An
Bord
Pleanála

Inspector's Report ABP316288-23

Development	Protected Structure: construction of single and 2-storey extension, internal and external works and new vehicular access from Palmerston Road.
Location	42H Palmerston Road, Rathmines, Dublin 6.
Planning Authority	Dublin City Council.
Planning Authority Reg. Ref.	4439/22.
Applicant(s)	Frank and Rebecca Mitchell.
Type of Application	Permission.
Planning Authority Decision	Grant subject to condition.
Type of Appeal	First Party
Appellant(s)	Frank and Rebecca Mitchell.
Observer(s)	Richview Residents Association.
Date of Site Inspection	21/06/2023.
Inspector	Anthony Abbott King.

Figure 1: Street Trees and Vehicular Entrances

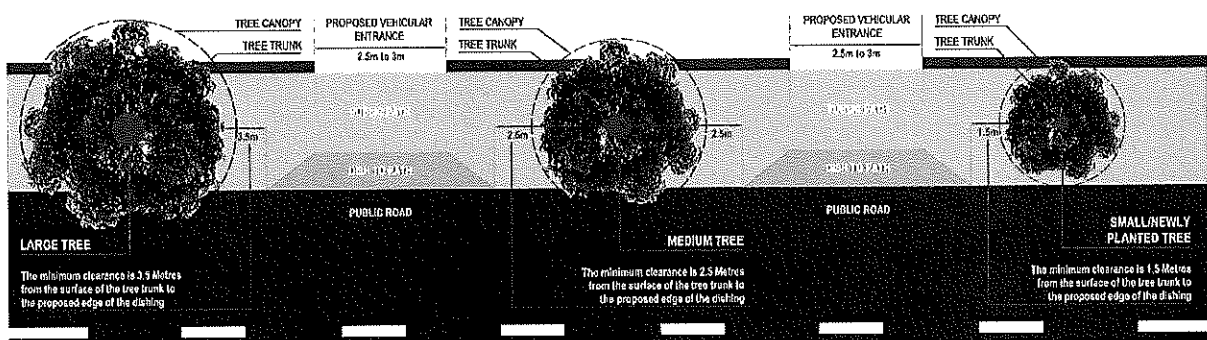
Section 4.3.2, Figure 1 illustrates the various minimum clearance distances required, based on the maturity of the street tree. The minimum clearance distance for a mature tree is given as 3.5 metres from the surface of the tree trunk to the proposed edge of the dishing of the footpath. The dishing of the footpath usually extends to 900mm beyond the edge of the vehicular entrance on each side. It is considered that

the amended distance of 2.768 from the proposed access to the tree trunk would therefore be insufficient to satisfy the minimum clearance criteria and would potentially negatively impact on the subject tree and root zone.
